**CITY OF AUSTIN
Board of Adjustment
Decision Sheet**

CASE NUMBER: C15-2017-0047

ADDRESS: 3602 & 3604 RIVERCREST DR

Wetlands Biologist Review - Liz Johnston - 512-974-2619

Aerial Photo from 2006

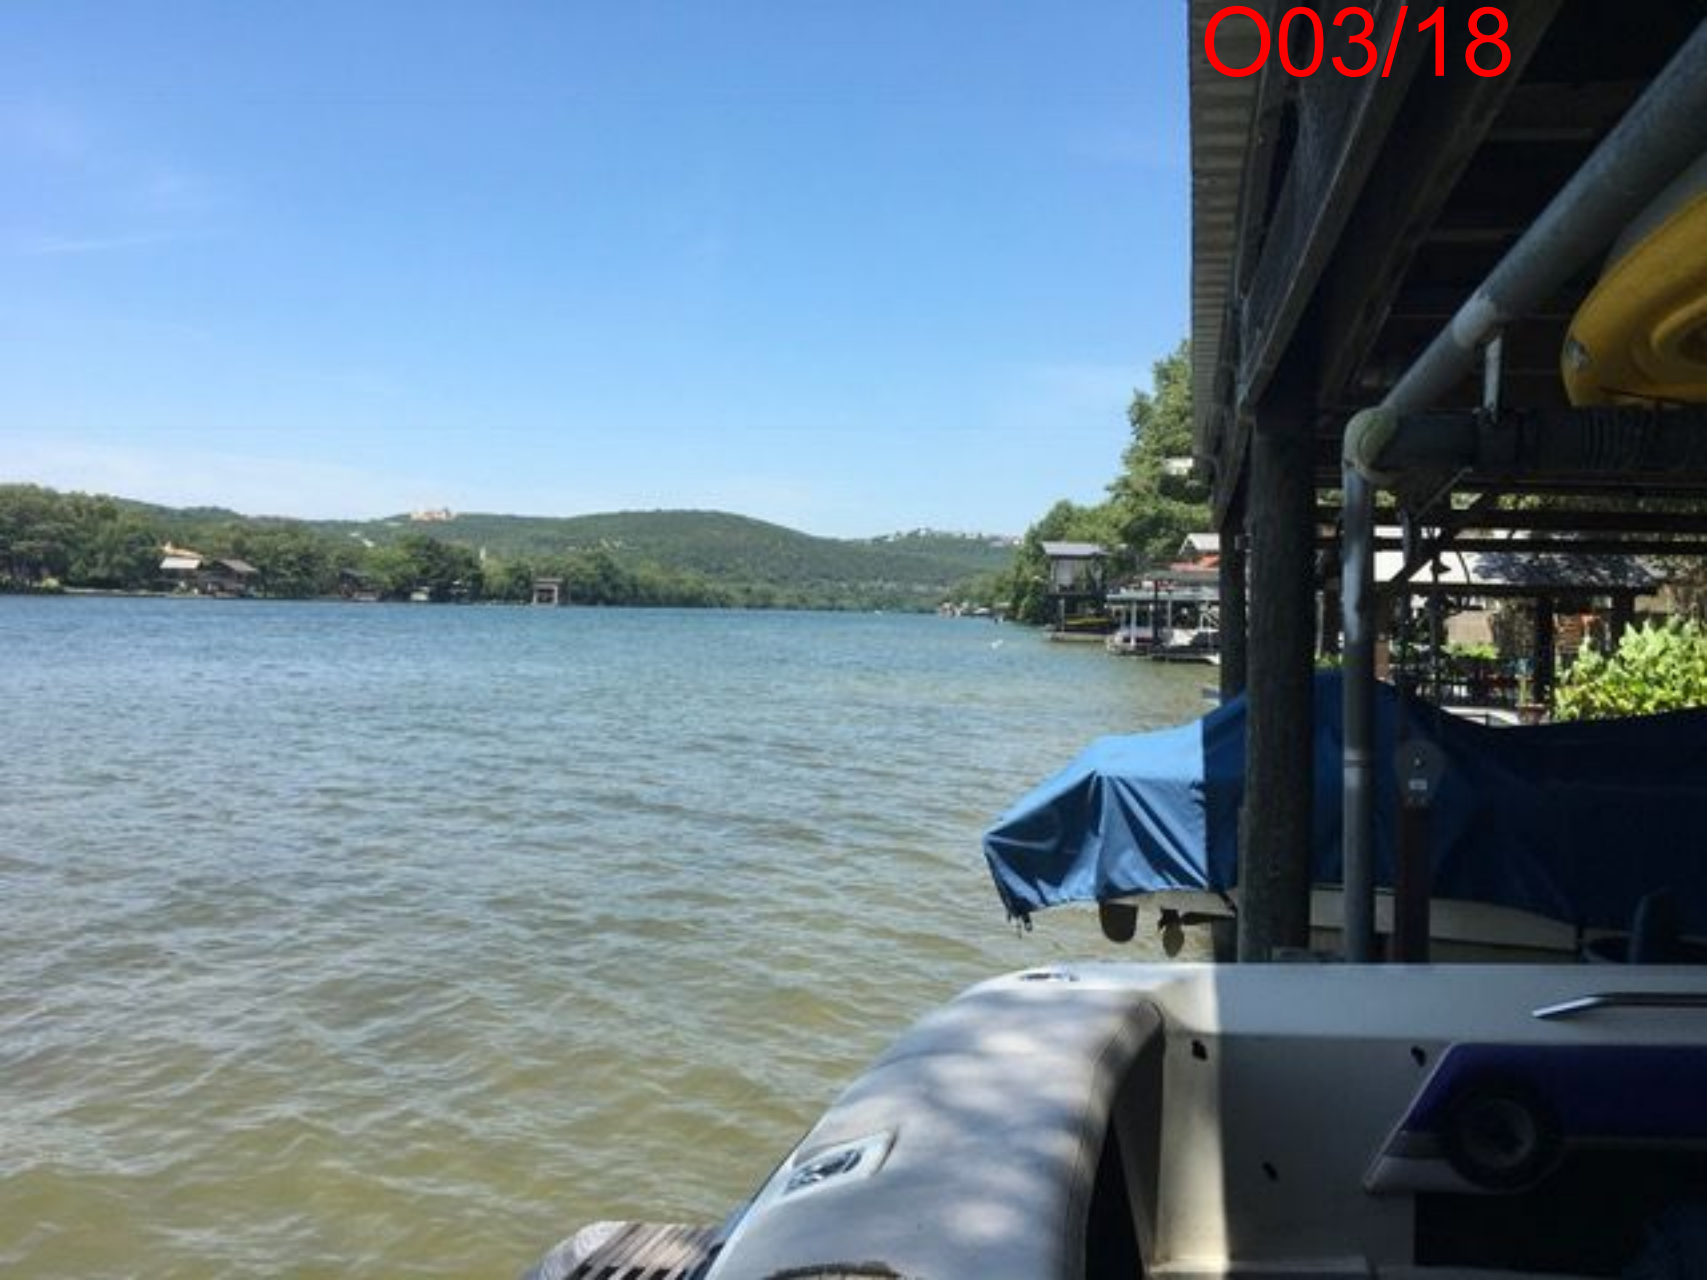
This memo is intended to provide relevant information related to a case before the Board requesting a variance to extend a dock greater than 30' into Lake Austin. Three adjoining properties along Rivercrest Dr, including 3602 and 3604 Rivercrest, are under an environmental code violation related to unpermitted land capture that occurred in 2009 when a new bulkhead was constructed up to approximately 15' from the previous shoreline. Previously inundated waters were backfilled and converted to yard area. When the work occurred, a site plan for a new bulkhead would have been required with approval of the Parks Board for the shoreline modification and environmental variances for construction not allowed within a Critical Water Quality Zone. However, no permits were secured for the work. See enclosed aerial imagery for reference.
